Illustrated Parts List - IPL Update

390 XP

Description of change

1. Screw

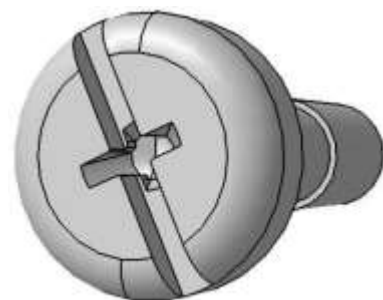
1. New screw with torx grip to cylinder cover provides better condition for tightening. Torx wrench added in tool kit.
2. Torx wrench added in tool kit. Tool kit included in box. Grease and Grease gun removed from tool kit.
3. Torx wrench T27/T20 available as spare part.
4. New sealing ring.

588 48 73-01
